CONTRACT NO. 1800

WET WEATHER PUMP STATION

ADDENDUM NO. 11

ALLEGHENY COUNTY SANITARY AUTHORITY WASTEWATER TREATMENT PLANT WET WEATHER PUMP STATION		Contract: 1800
430-A-28 WALL SECTIONS 1		CAD File Name:
		Date: 5/16/2025
		Sheet: 79 of 405

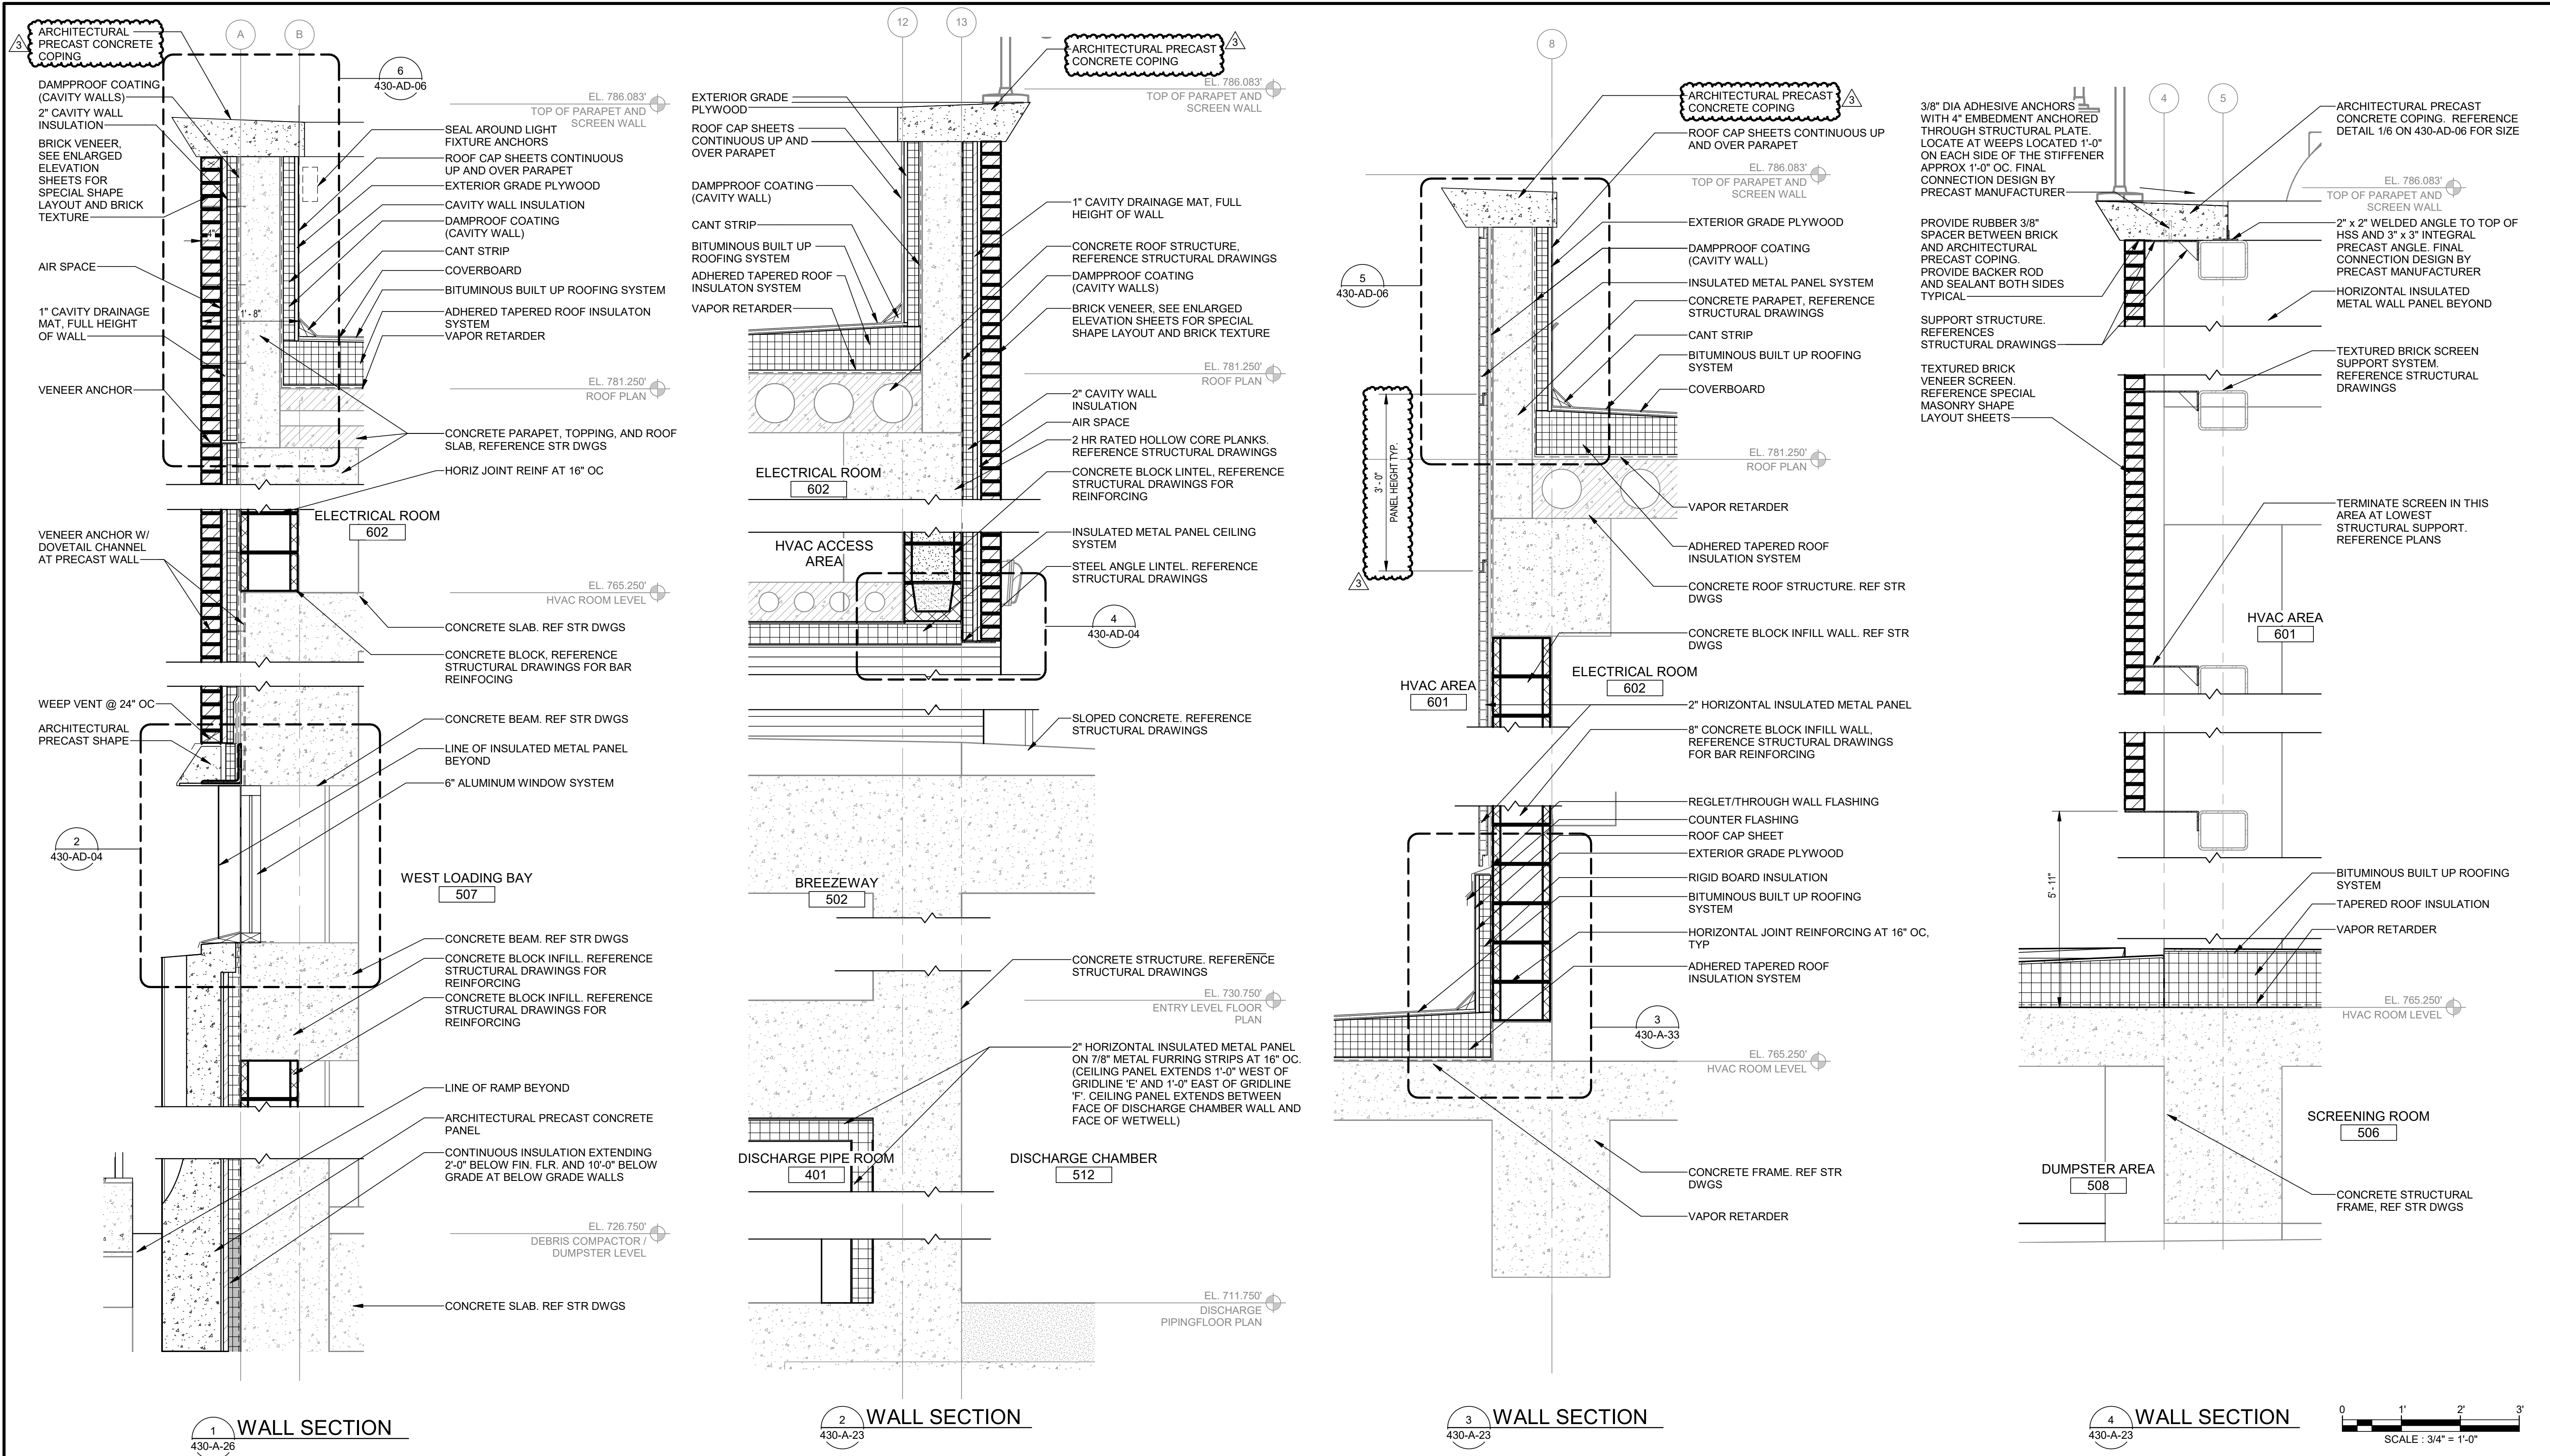
- Q34:** Detail 3/430-AD-04, 3/430-A-28 and 1/430-A-33, indicate the panel module width to be 2'-6". This however conflicts with the Specifications 2.03.1 which specifies the panel module to be 3'-0". Please clarify that the 2'-6" width in the Drawings is correct.

- A34:** The 3' Panel module noted in the specifications is the correct module. Refer to Items 4.10, 4.11, 4.12 and 4.13 of Addendum No. 11.
- Q35:** Drawing 430-AD-01 and numerous others shows the panel module thickness as 2". This however conflicts with the Specifications 2.03.4 which specifies the panel thickness to be 3" or to provide 4" when used in conjunction with Fire Resistant Wall Panels. Please clarify that the IMP panels, erected to masonry and/or concrete walls, are not intended to provide fire resistance and that the 2" panel thickness in the Drawings is correct.
